WELL LOCATION AND ACREAGE DEDICATION PLAT

## PECOS DISTRICT DRILLING CONDITIONS OF APPROVAL

<b>OPERATOR'S NAME:</b>	<b>APACHE CORPORATION</b>
<b>LEASE NO.:</b>	<b>NMNM0039880</b>
<b>WELL NAME &amp; NO.:</b>	<b>GHOST RIDER 22 15 FEDERAL COM 31H</b>
<b>SURFACE HOLE FOOTAGE:</b>	<b>2272'S &amp; 540'E</b>
<b>BOTTOM HOLE FOOTAGE:</b>	<b>50'S &amp; 743'E</b>
<b>LOCATION:</b>	<b>Section 15, T.24 S., R.32 E., NMP</b>
<b>COUNTY:</b>	<b>Lea County, New Mexico</b>

# Application Data Report

(Test annular to 50% WP)

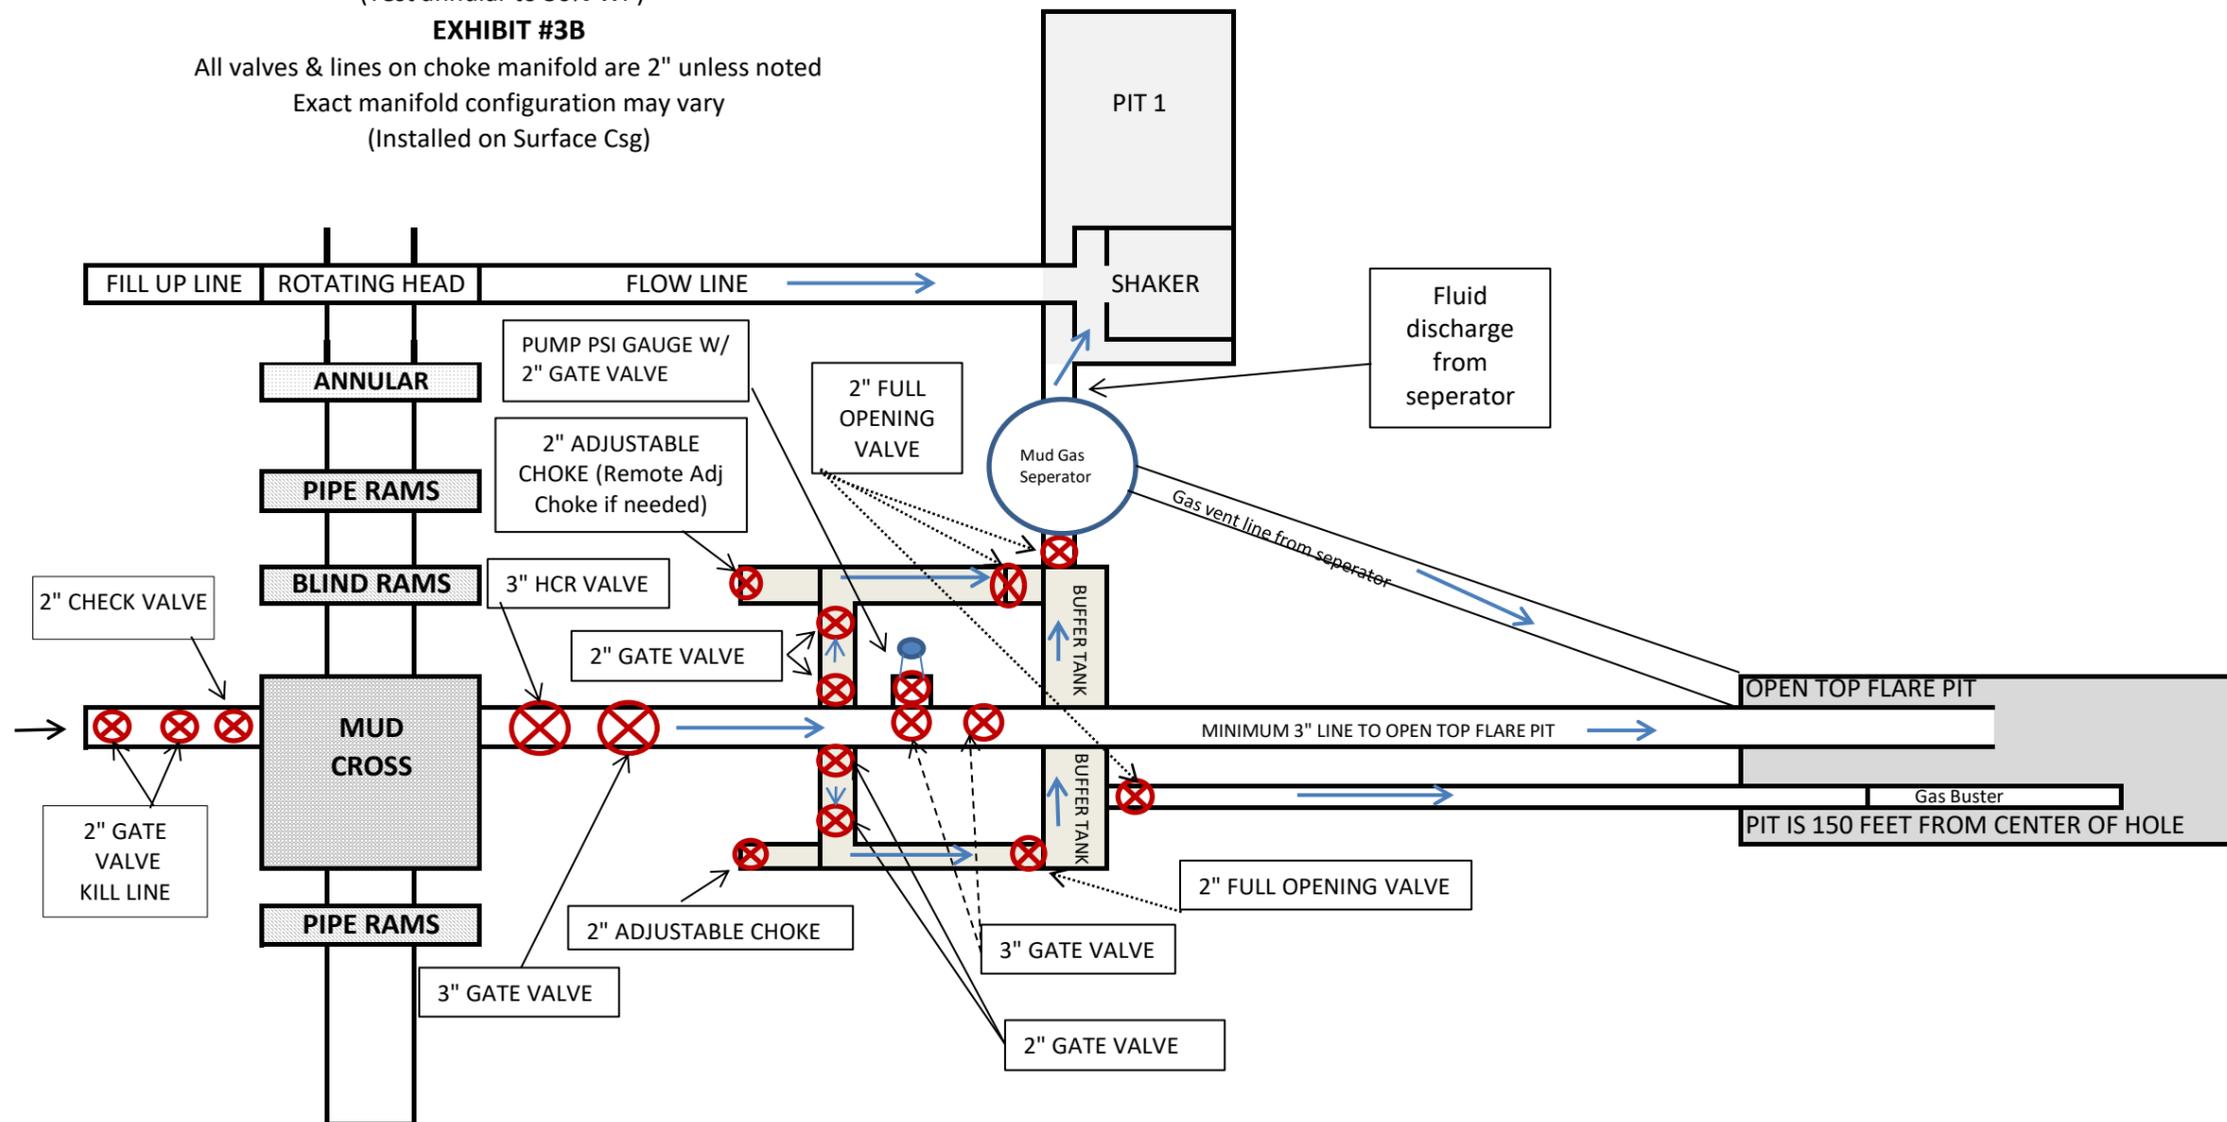
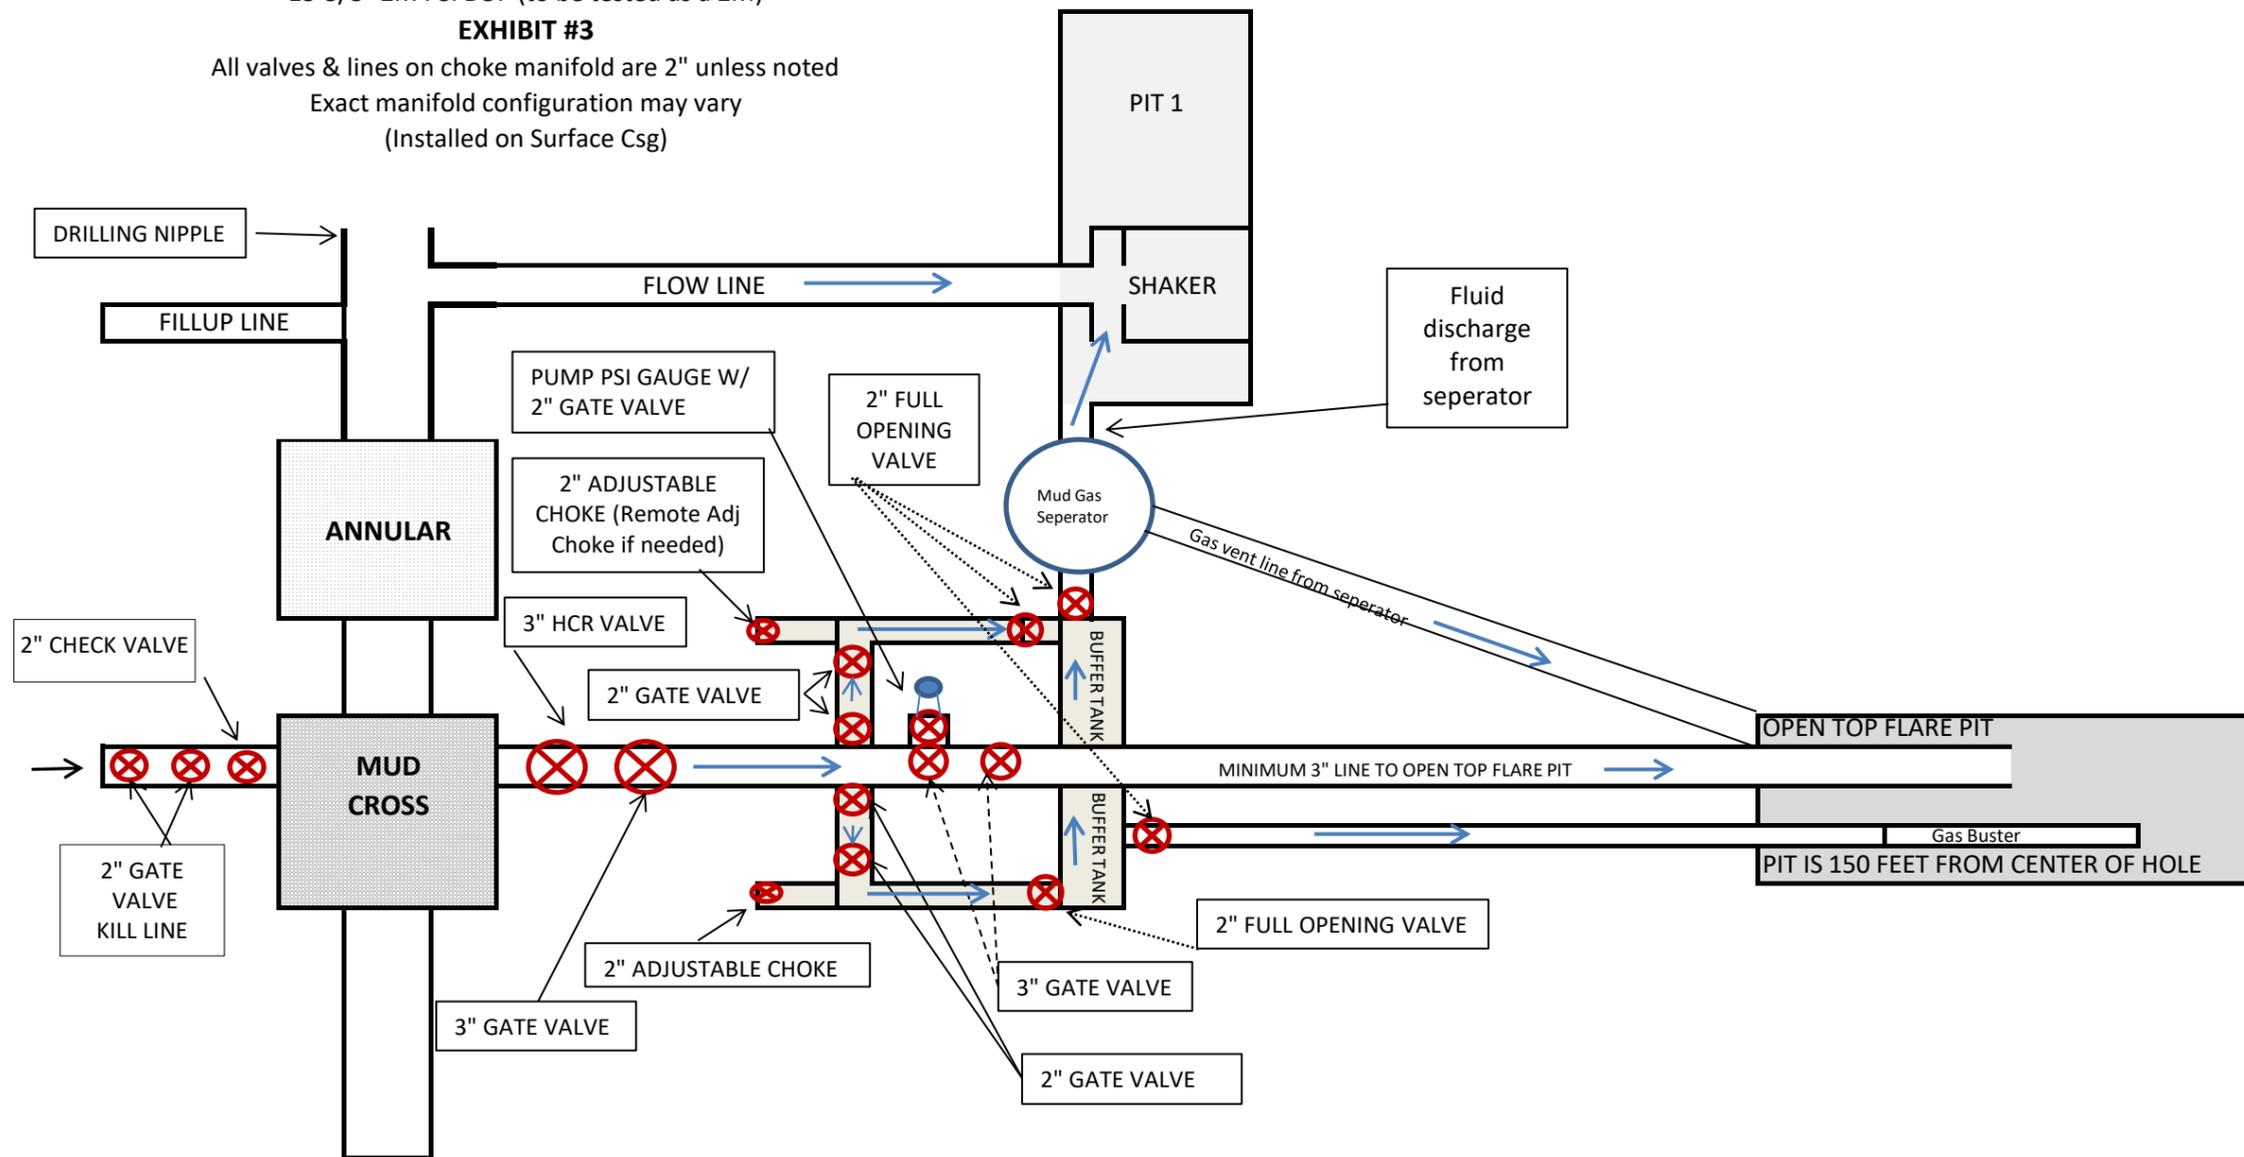
1. Variance approved to use flex line from BOP to choke manifold. Manufacturer's specification to be readily available. No external damage to flex line. Flex line to be installed as straight as possible (no hard bends).'
- 2.

- a. Minimum working pressure of the blowout preventer (BOP) and related equipment (BOPE) required for drilling below the surface casing shoe shall be **2000 (2M)** psi.
- b. Minimum working pressure of the blowout preventer (BOP) and related equipment (BOPE) required for drilling below the intermediate casing shoe shall be **3000 (3M)** psi.

1. Operator has proposed a multi-bowl wellhead assembly. This assembly will only be tested when installed on the surface casing. Minimum working pressure of the blowout preventer (BOP) and related equipment (BOPE) required for drilling below the surface casing shoe shall be **3000 (3M)** psi.
